Project	IEEE 802.16 Broadband Wireless Access Working Group < http://ieee802.org/16 >
Title	Corrections on Open loop power control for uplink
Date Submitted	2004-11-01
Source(s)	Jaehee Cho, Seungjoo Maeng, Jaeho Jeon, jaehee1.cho@samsung.com Soonyoung Yoon, Jeong-Heon Kim, Jaehyok Lee, Myungkwang Byun, Inseok Hwang, Panyuh Joo, Jiho Jang, Sanghoon Sung, Hoon Huh, janghoon yang, ByoungHa Yi Samsung Electronics Co. Ltd.
Re:	Recirculation of P802.16 REVe/D5
Abstract	The current description of open loop power control has some errors. This contribution presents corrections for them.
Purpose	Adoption of suggested changes into P802.16e/D6
Notice	This document has been prepared to assist IEEE 802.16. It is offered as a basis for discussion and is not binding on the contributing individual(s) or organization(s). The material in this document is subject to change in form and content after further study. The contributor(s) reserve(s) the right to add, amend or withdraw material contained herein.

Suggested text changes to 16.e standard

Figure 20c - Bandwidth request and UL Tx power report header format

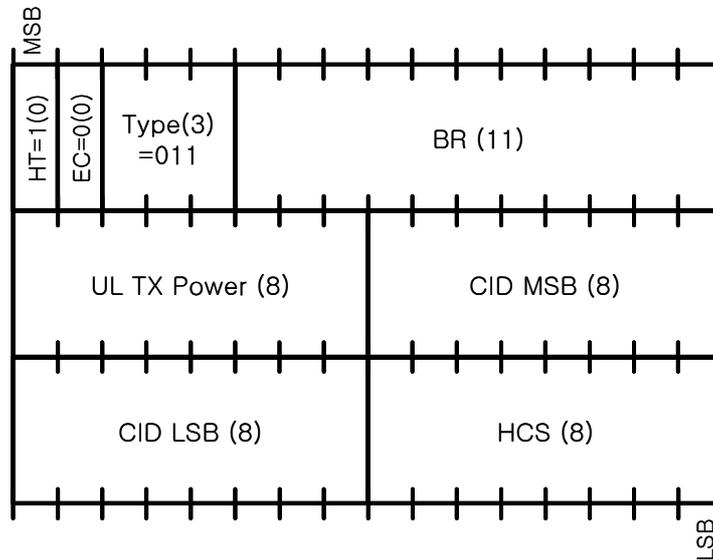
[Change the text as follows in 6.3.2.1.5]

The Bandwidth Request and UL Tx power report PDU shall consist of bandwidth request and UL Tx power report header alone and shall not contain a payload. The bandwidth request and UL Tx power report header is illustrated in Figure 20c.

The ~~the~~ bandwidth request and UL Tx power report header shall have the following properties:

- The length of the header shall always be 6 bytes.
- The EC field shall be set to 0, indicating no encryption.
- The CID shall indicate the SS basic CID.
- The TYPE field should be "011".
